CFA CONCEPT REVIEW SUBMISSION

Commission of Fine Arts
Filing Date April 3rd, 2025
Meeting Date June 18th, 2025

CAPITAL ONE ARENA TRANSFORMATION

EXISTING

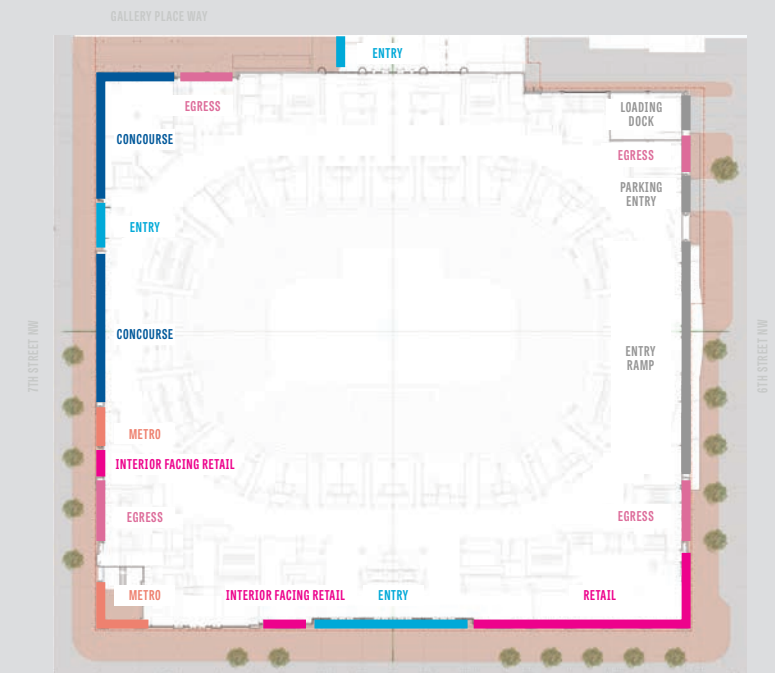
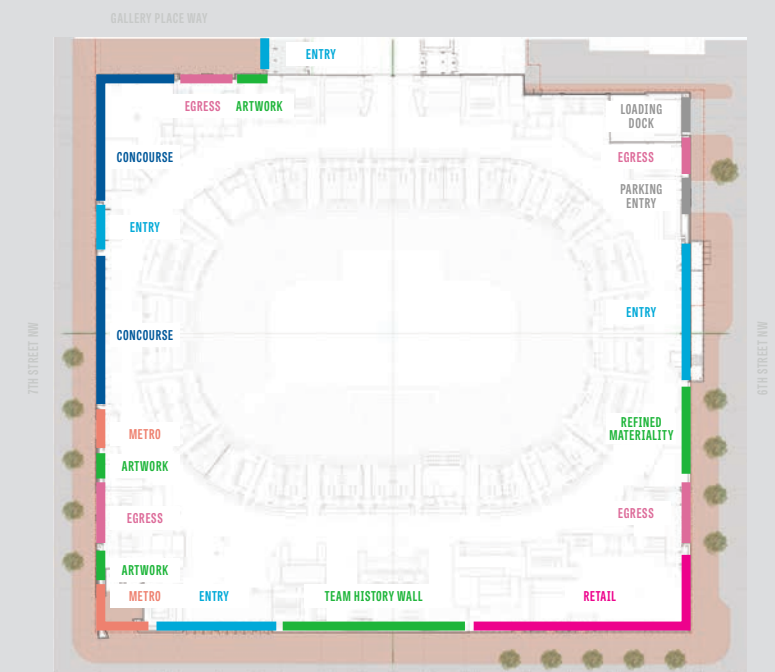
"..they expressed concern that the proposed strategy of removing existing exterior-facing retail spaces in favor of improved access and amenities for scheduled arena events would compromise the daily vitality of the surrounding urban fabric."

Response: While as a general planning principle the inclusion of ground floor retail in buildings is an important ingredient to creating active, pedestrian-friendly streetscapes, the success of the ground floor retail spaces in the arena have underperformed since their construction. As shown in the drawings, there are challenges to maintaining all existing ground level retail space due to the size and orientation of the arena bowl and other immutable core building elements, and practical realities of the retail market for the foreseeable future. Given site constraints, the bowl and concourse literally extend to the 6th and 7th Street facades, leaving only the four corners of the building for ancillary programming and/or public-facing retail. Two of these corners are fully encumbered by the Metrorail entrance and loading facilities and thus cannot accommodate street-facing retail. The arena is also anchored at all four corners by large egress stairs and elevator shafts for both the arena and Metrorail that further encumber the extremely limited ground floor space.

Generally speaking, the remaining spaces at the northwest and southeast corners of the arena have never been competitive retail spaces due to their shallow depth and awkward configuration. As shown in the drawings, these are not well-configured retail spaces that easily garner strong tenant demand even under normal market conditions, and certainly not in a weakened, post-COVID retail environment where tenants are in search of higher-quality space that is flexible and has high visibility. As part of the Project, the existing retail space at the southeast corner of the arena will be retained. At the northwest corner, the former retail space will be better utilized and repurposed for interior fan experience. Along F Street, the project will shift the main arena entrance to the location of the vacant retail space to address significant entry access and circulation issues caused by major vertical circulation (elevators and escalators) located directly in line with the current main entrance.

The arena is a destination that is active over 220 days per year and drives a footfall of approximately 2.5M people to the area. Thus, the repurposing of what has been fairly underperforming (and now vacant) retail space to improve the fan experience and arena access will bring even more people to the arena, thereby catalyzing an enhanced street presence and strengthened retail demand on the surrounding blocks, which continue to experience some of the highest rates of vacancy in the city due in part to permanent COVID-induced shifts to online retail and impacts of remote/hybrid work on downtown foot traffic. Through the combination of the arena transformation and the District's efforts to re-activate the Gallery Place neighborhood, the arena will become part of a larger, revitalized neighborhood and cultural-entertainment destination that is hopefully supported by strong, vibrant retail uses around the arena that substantially benefit from the millions of fans and event goers that visit the arena.
